ITB # 201911 – MSV Trails

Questions & Answers

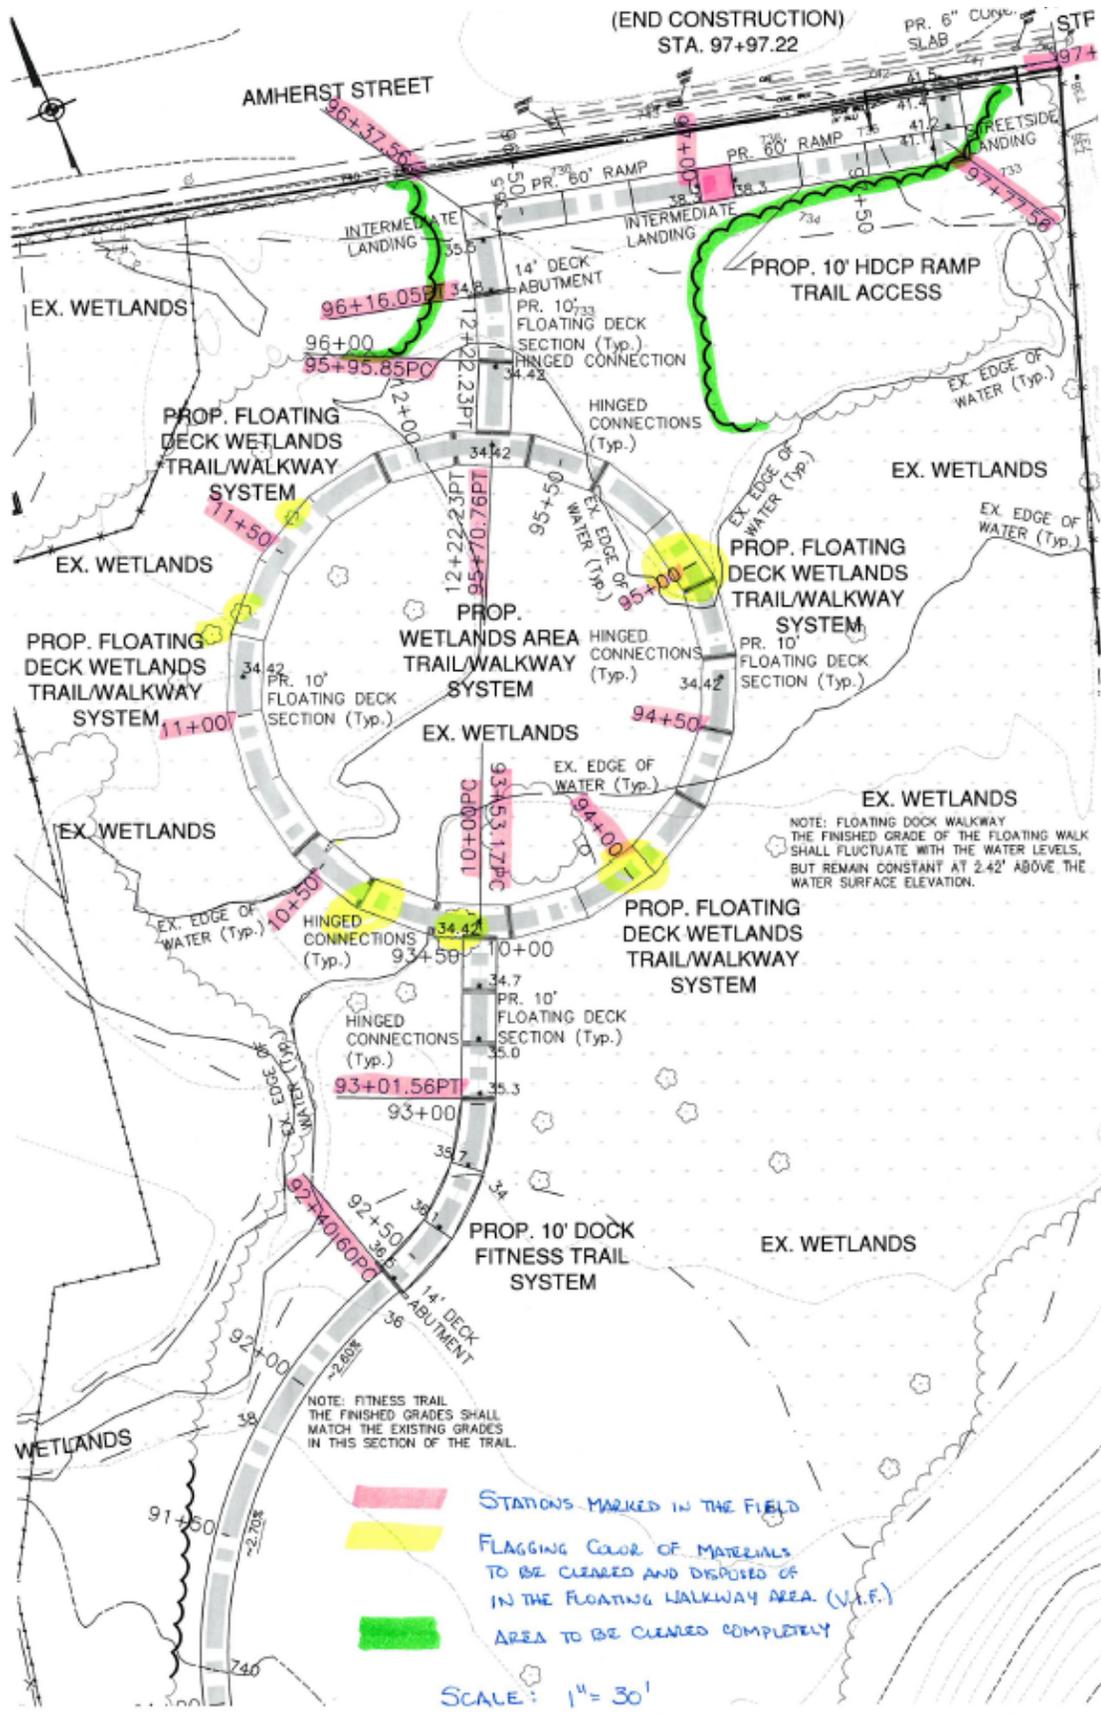
- Q9. Can the wetlands cleanup and trail locations be marked in the field?
A9. The wetlands cleanup and floating walkways have been marked in accordance with the diagram below (note that since this was pasted into this document it is no longer to scale).

- STATIONS MARKED IN THE FIELD
- FLAGGING COLOR OF MATERIALS TO BE CLEARED AND DISPOSED OF IN THE FLOATING WALKWAY AREA (V.I.F.)
- AREA TO BE CLEARED COMPLETELY
